64 Blueberry Rd

Site Alterations

OVERALL SITE PLAN
 OF
ECOMAINE WASTE-TO-ENERGY PLANT
 64 BLUEBERRY ROAD
 PORTLAND, MAINE
 FOR
ECOMAINE
 64 BLUEBERRY ROAD
 PORTLAND, MAINE 04102

ECOMAINE PARKING EXPANSION

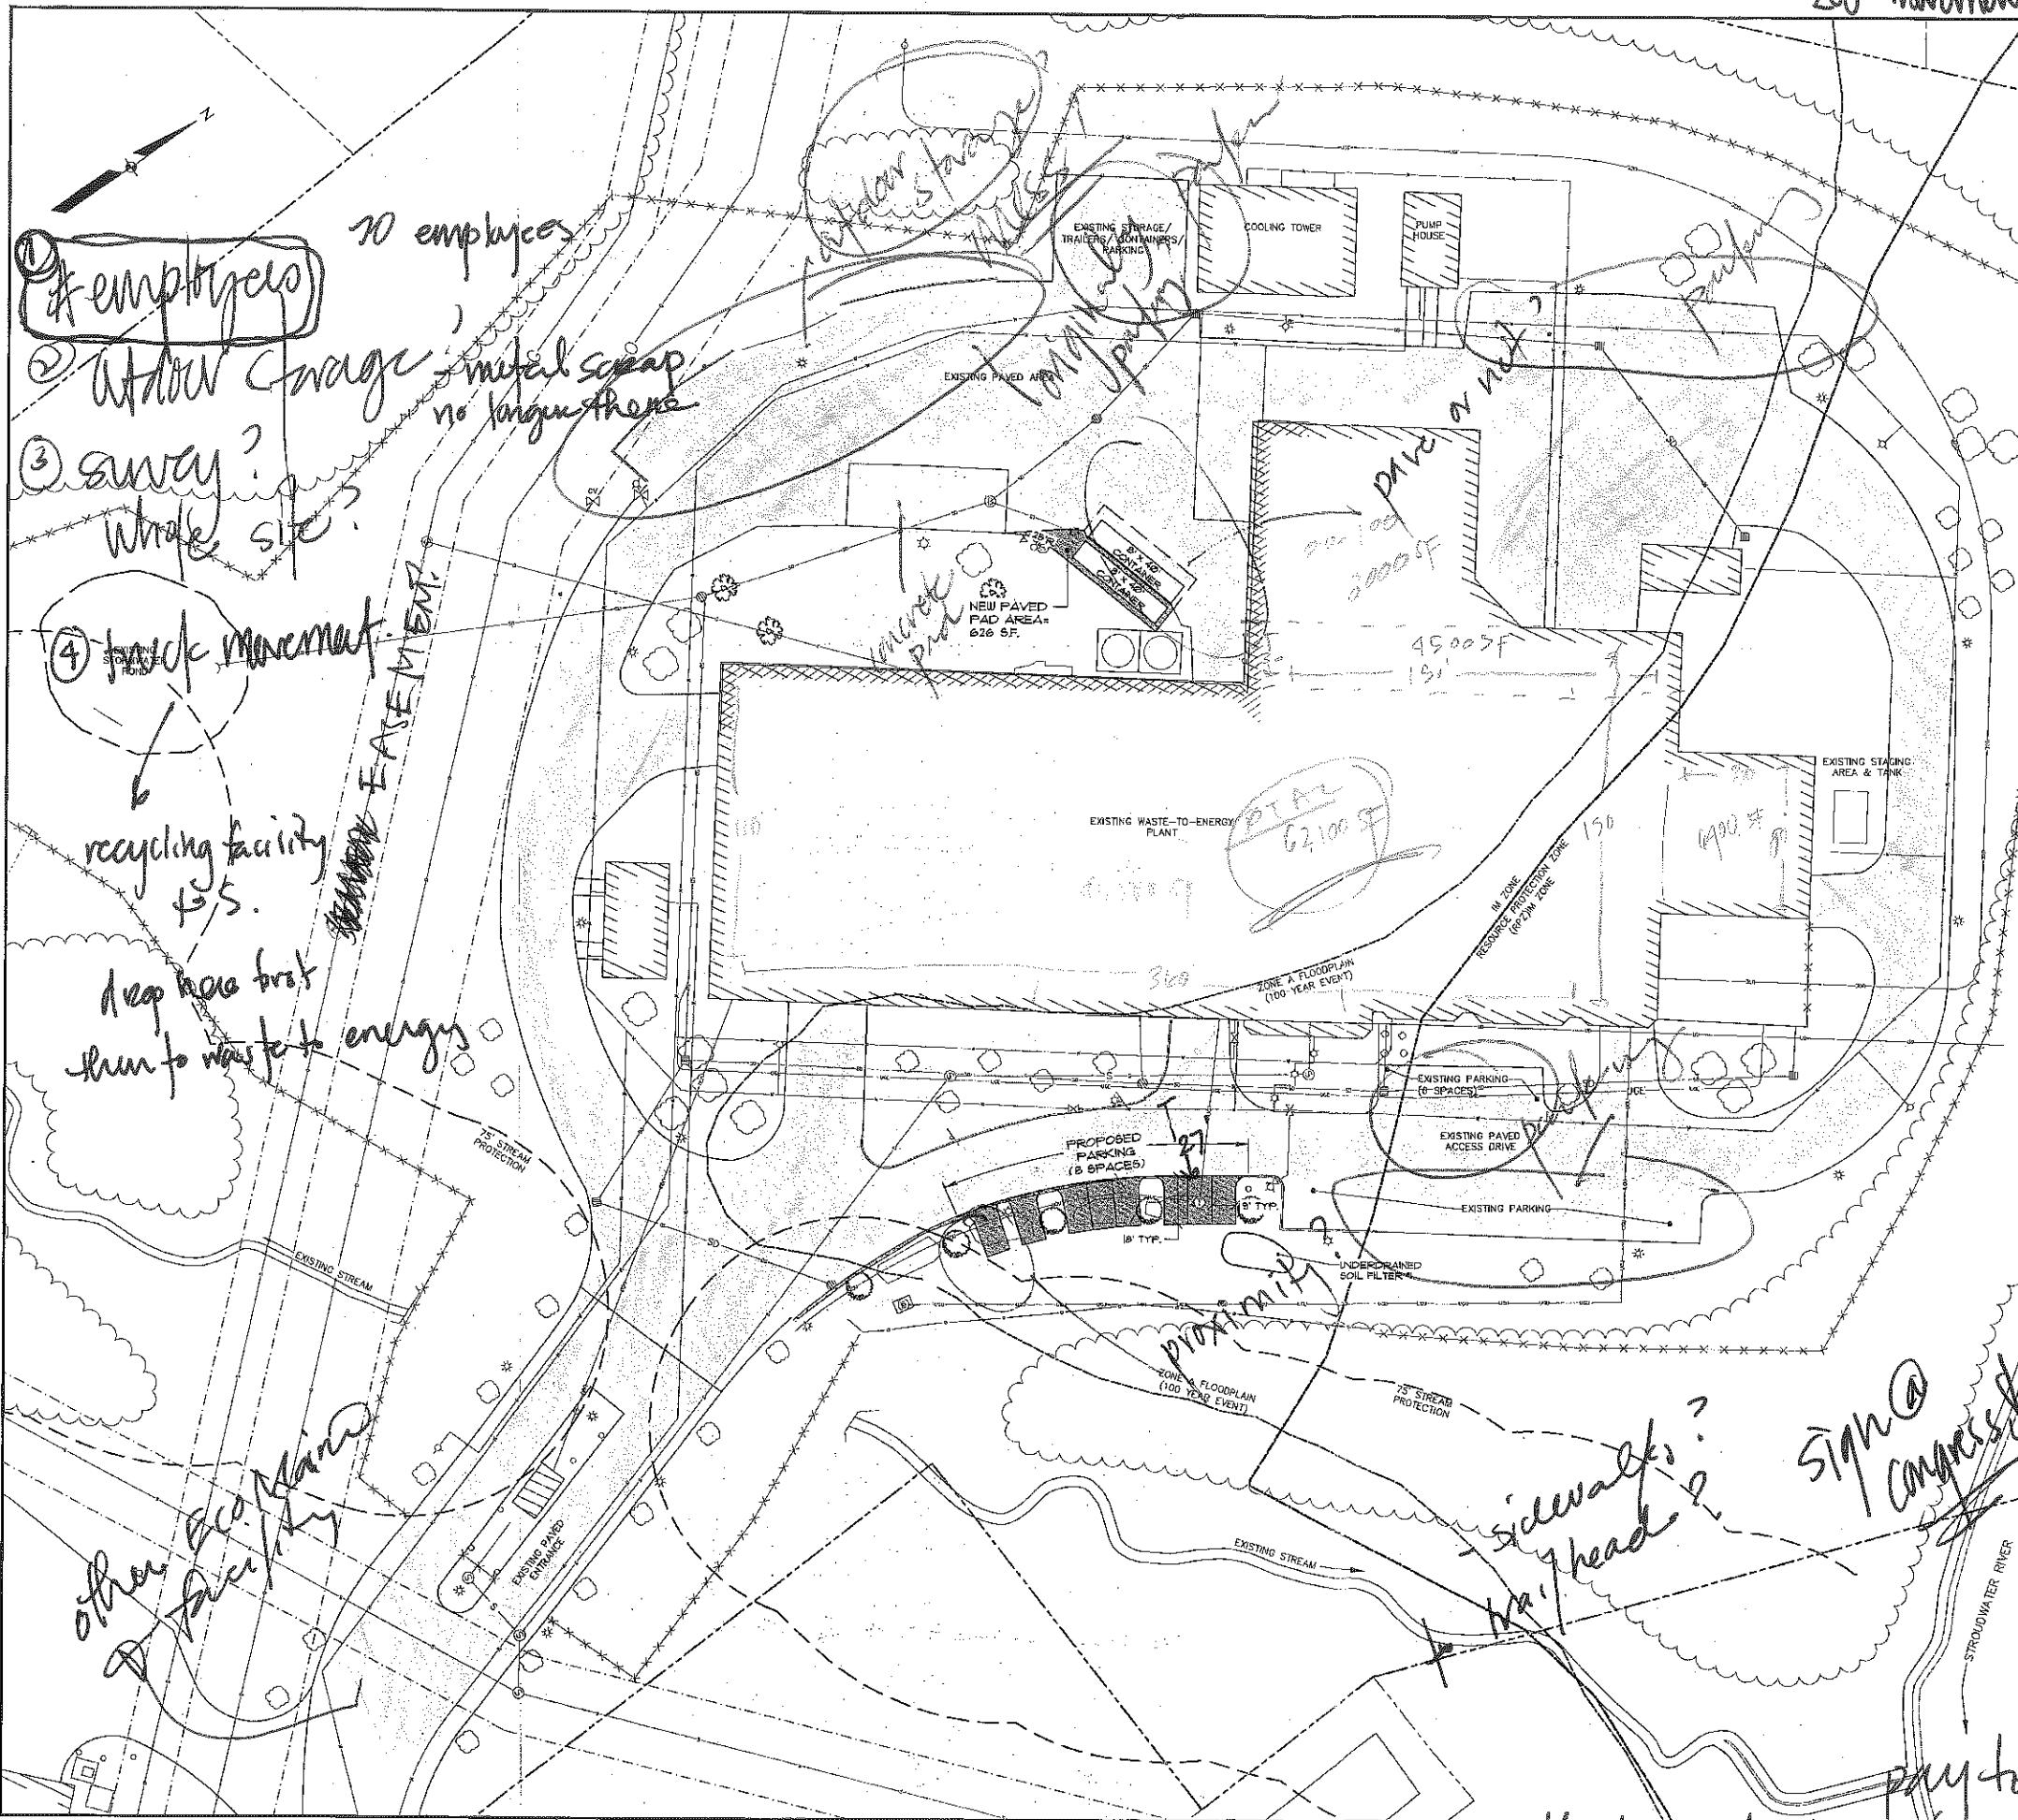
pk. Expansion

200 movements/day - trucks

70 employees

① employees
 ② Adair Garage - metal scrap no longer there

③ sway? whole site?

④ truck movement

recycling facility 1/5

keep here first then to waste to energy

proximity
 sidewalks?
 half head?

sign @ Congress

methadone clinic sidewalk fund - pay to

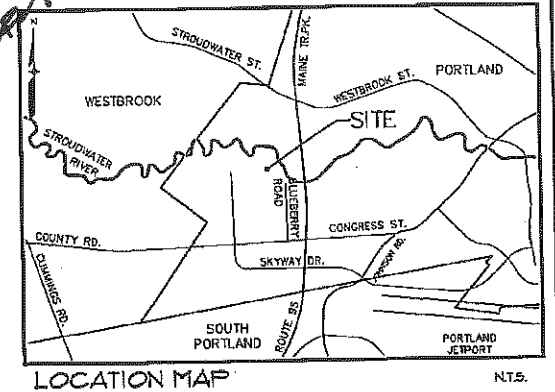
61
1 AKSF over 3/45F
61 spaces

23 spaces
IM ZONE
RESOURCE PROTECTION (RPZ)

21 ravine
overburdened
w/ storage

23 spaces
